Work Order ID 89018

Item Name: Crosstube Fwd

Reference: NCR 12-1695

DART SERVICE INSTRUCTION

FIGURE 1 - GROUNDING STRAP INSTALLATION
(VIEW LOOKING FWD)

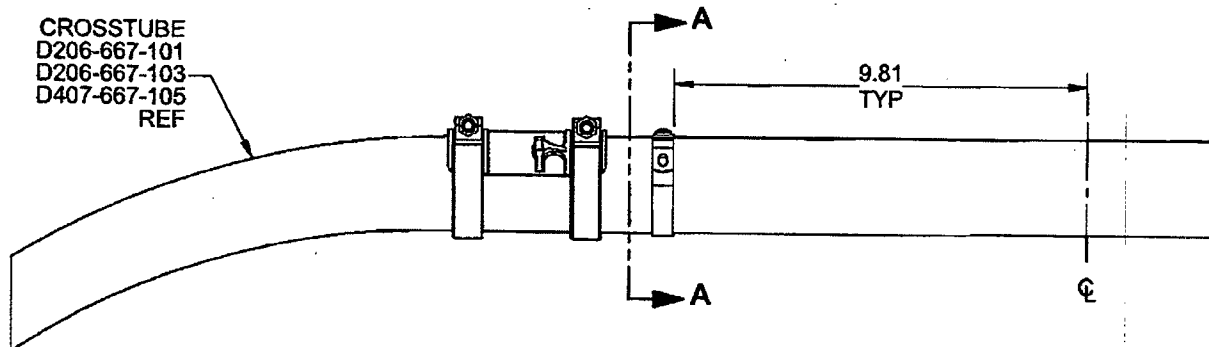
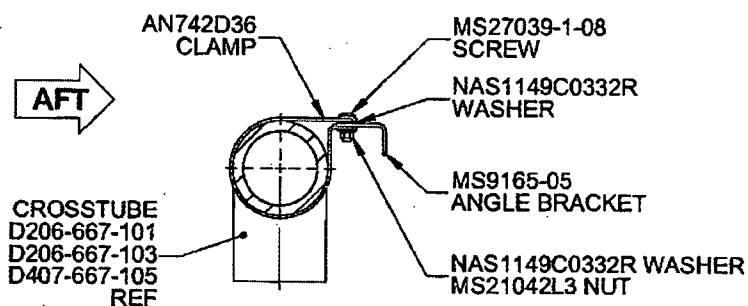
The purpose of this service instruction is to add the optional D206-667-017 Kit and provide guidelines to install extra clamps on D206-667-101/-103 or D407-667-105 forward crosstubes to allow fastening of OEM grounding straps.

- 1) If installed, follow Section 32.1 of ICA-D206-667 for removal of the forward crosstube from the helicopter.
- 2) Locate AN742D36 Clamp as shown in Figure 1 of this service instruction and mark location of clamp on the crosstube.

- 4) Install AN742D36 Clamp complete with MS9165-05 per Section A-A of Figure 1 of this service instruction.
- 5) Touch up paint as required per Item 5.3.3 of ICA-D206-667.
